SERVICE BULLETIN

PURPOSE : CORRECTION	ISSUE NO. : MSB-13E23-501	DATE : 2013-10-29
SUBJECT : DIAGNOSIS CODE No.P0942: Electric Oil Pump Status		<Affected Destination/Model> (EUR) <M/Y> 13-14
GROUP : AUTOMATIC TRANSMISSION(Gr:23)		MIRAGE/SPACE STAR(A03A) OUTLANDER(GF0W)

Please refer to the attached document (Attached sheet 4-5)
(The procedure of diagnosis code No.P0942 has been corrected due to its error in writing in the service manual)

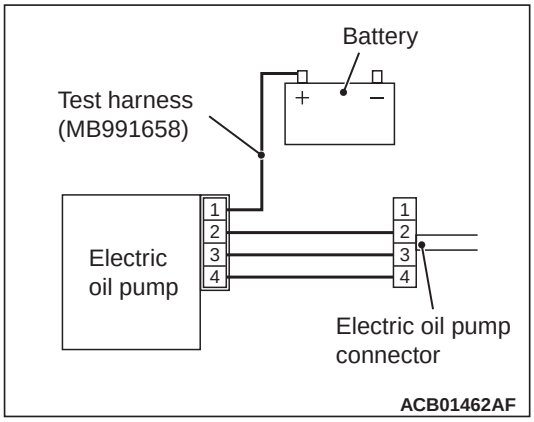
<Incorrect>

STEP 8. Perform voltage measurement at electric oil pump connector (power supply terminal).
(1) Disconnect the connector, and measure at the wiring harness side.
(2) Measure the voltage between the electric oil pump connector (power supply terminal) and body earth.
(3) Turn the ignition switch to the "ON" position.

<Correct>

STEP 8. Perform voltage measurement at electric oil pump connector (EOPI terminal).
(1) Disconnect the electric oil pump connector, and measure at the wiring harness side.
(2) Measure the voltage between the electric oil pump connector (EOPI terminal) and body earth.

STEP 10. Perform voltage measurement at CVT-ECU connector (EOPO terminal).

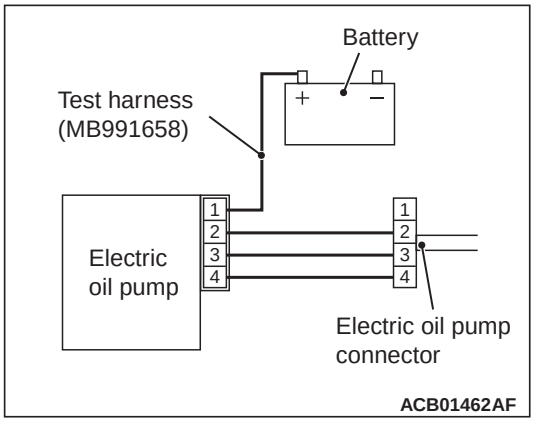
(1) Disconnect the electric oil pump connector and connect as in the figure using the special tool (Test harness: MB991658).
(2) Disconnect the CVT-ECU connector and measure the voltage between EOPO terminal and earth at wiring harness side.
(3) Turn the ignition switch to the "ON" position.
